RFB-2024-50
797 BROADWAY 1ST-3RD FLOORS INTERIOR RENOVATIONS
C2 DESIGN GROUP

ADDENDUM #2

Issued Date: 08/15/2024

1
G104 Second Floor Construction Phasing Plan
SCALE: 1/8" = 1'-0"

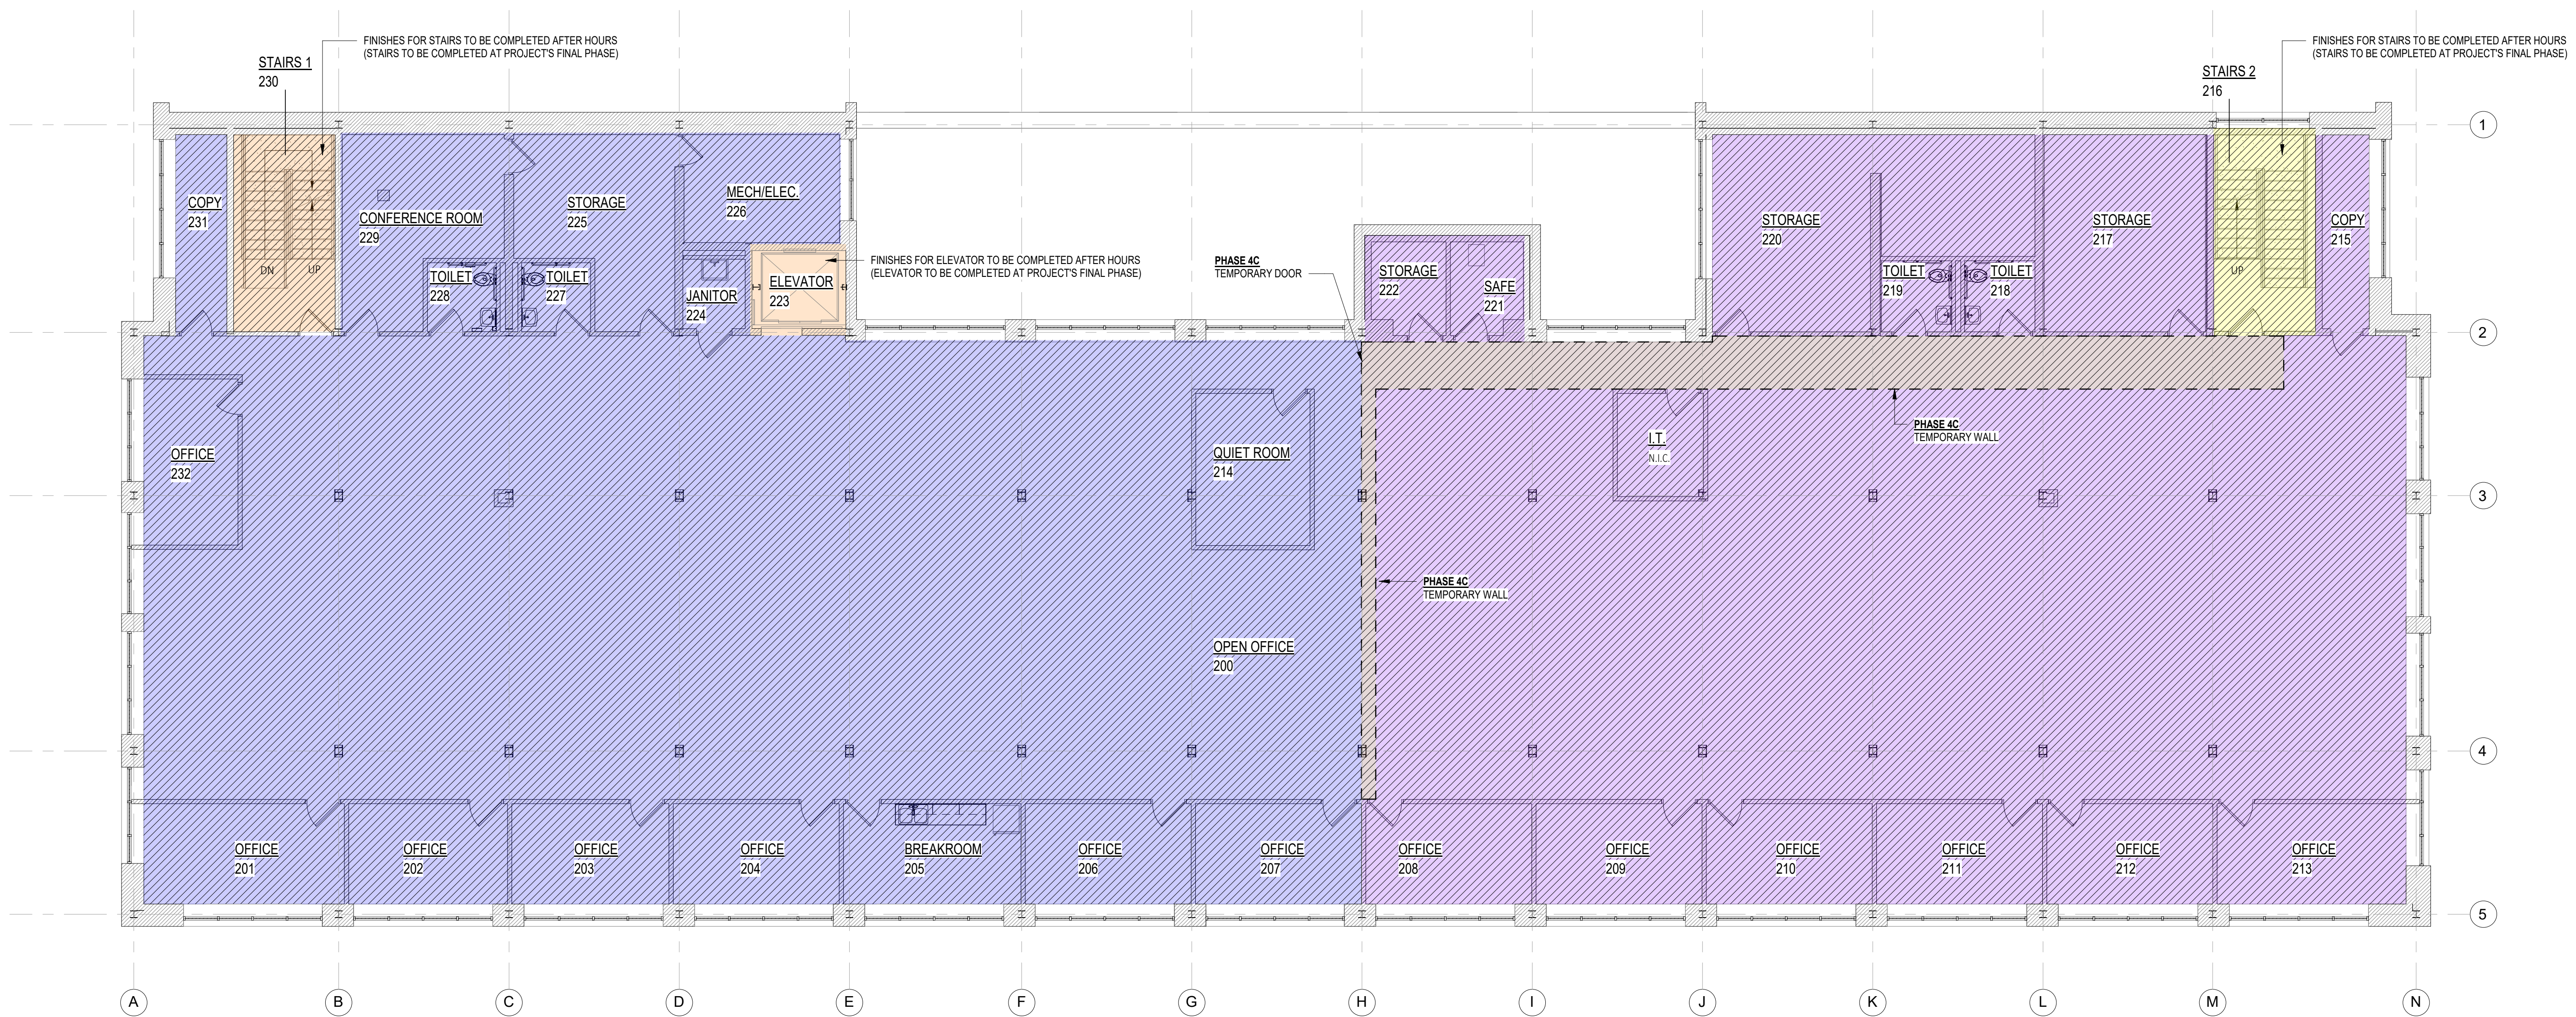
- a. Response: The G.C. is responsible for temporary relocation and storage of all furniture as directed by the County. See phasing plans for order of work.
